SUBJECT: Contract 9160  
SR99, AWV-Replacement South Access SR99 Connections  
**CHANGE ORDER #022**  
**SR99 Roadway Settlement Repair**

CONTRACT NO: 009160 FEDERAL AID NO:  
CONTRACT TITLE: SR 99, ALASKAN WAY VIADUCT - REPLACEMENT SOUTH ACC  
CHANGE ORDER NO: 22 SR99 ROADWAY SETTLEMENT REPAIR

**DESCRIPTION OF WORK**

SR 99	Plot 6
		ALASKAN WAY VIADUCT - REPLACEMENT	PLAN REF NO
		SOUTH ACCESS - SR 99 CONNECTIONS	BMD1
BARRIER MODIFICATION DETAILS		WEST	OF
		SHEETS

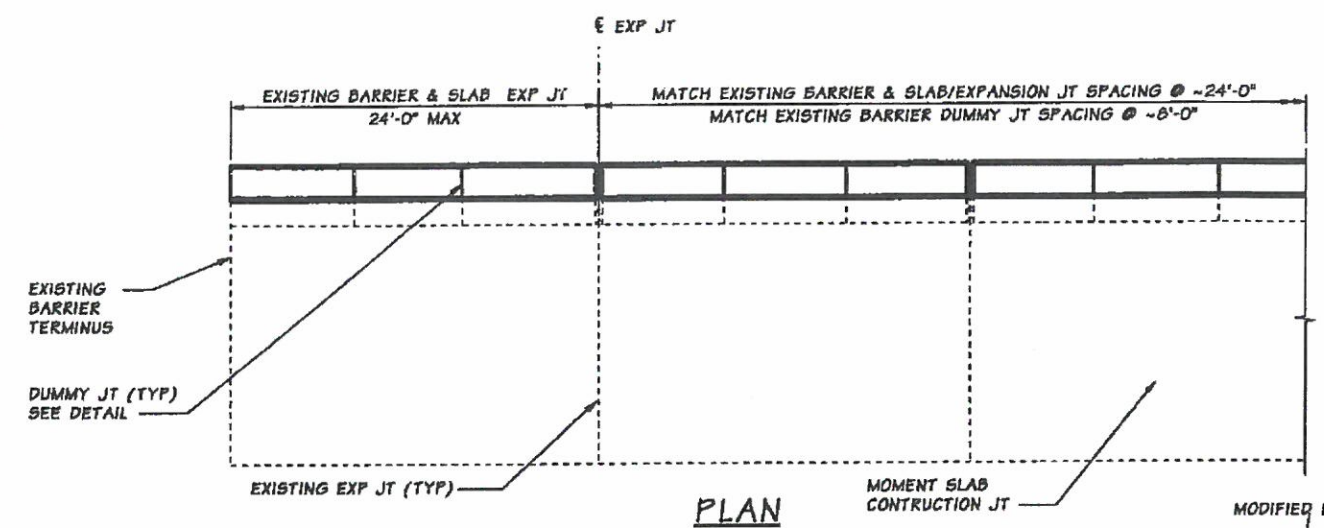
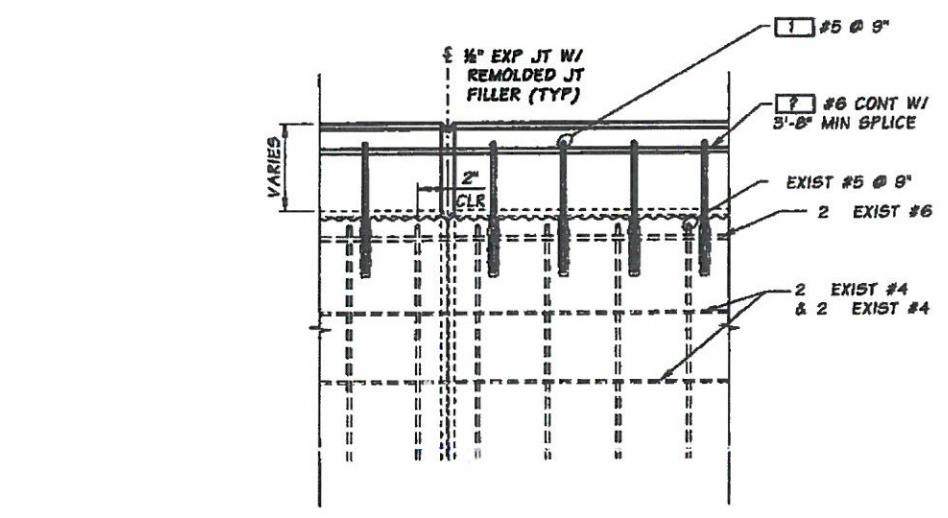
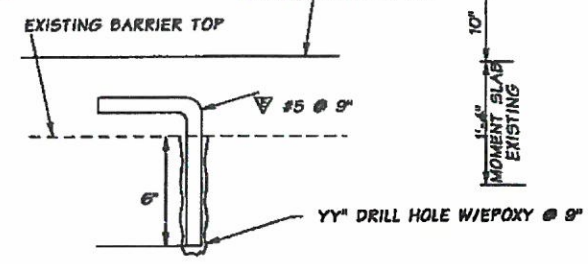
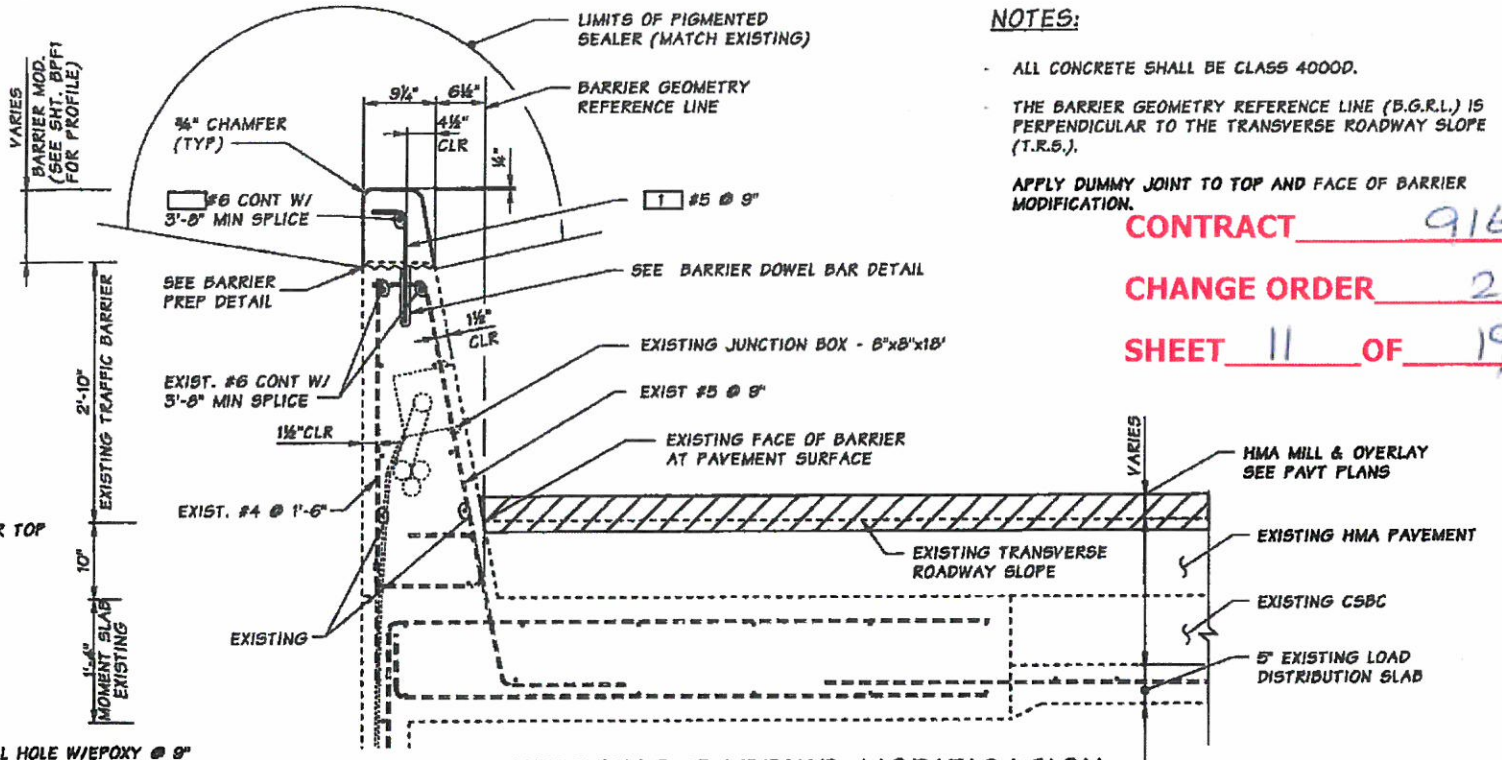
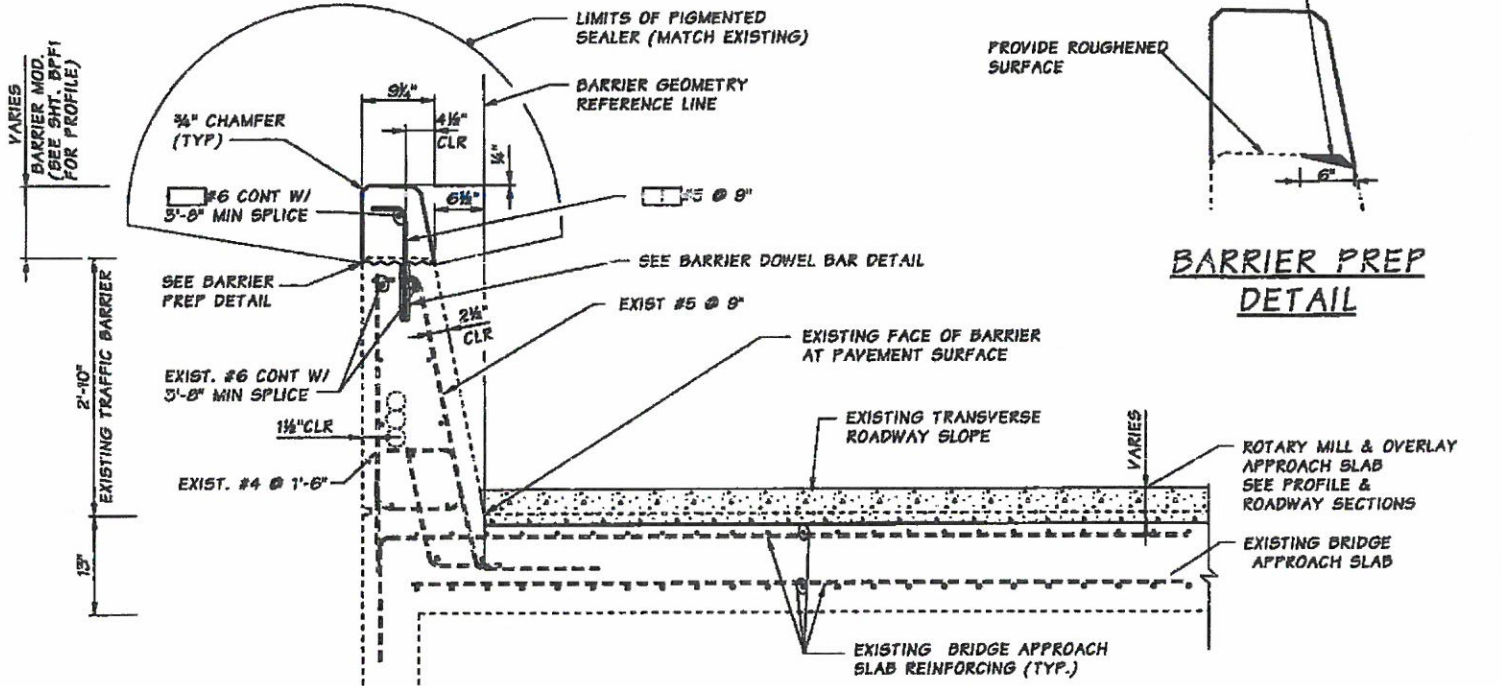
- (5) Modifies the barrier at the following locations:
  - S-SB 157+36.59 (39.36' LT) to S-SB 158+81.56 (34.72' LT)
  - S-SB 157+36.43 (27.29' RT) to S-SB 158+81.56 (21.01' RT)

- S-NB 157+13.39 (16.95' LT) to S-NB 158+57.58 (16.51' LT)
  - S-NB 157+12.55 (35.83' RT) to S-NB 158+57.58 (34.86' RT)
- (6) Implements the traffic control as shown in the plans. Adds temporary barrier and temporary striping to shift traffic in order to maintain access.

Section 6-02.2 of the 2016 Standard Specifications is supplemented with the following: "Epoxy bonding agent for steel reinforcing bar dowels shall be either Type I or Type IV, as specified in Section 9-26.1. The grade and class of epoxy bonding agent shall be as recommended by the resin manufacturer and approved by the Engineer."

Drilling Holes for, and Setting, Steel Reinforcing Bar Dowels-  
Where called for in the Plans, holes shall be drilled into existing concrete to the size and dimension shown in the Plans. The Contractor may use any method for drilling holes provided the method selected does not damage the concrete and the steel reinforcing bar that is to remain. Core drilling will
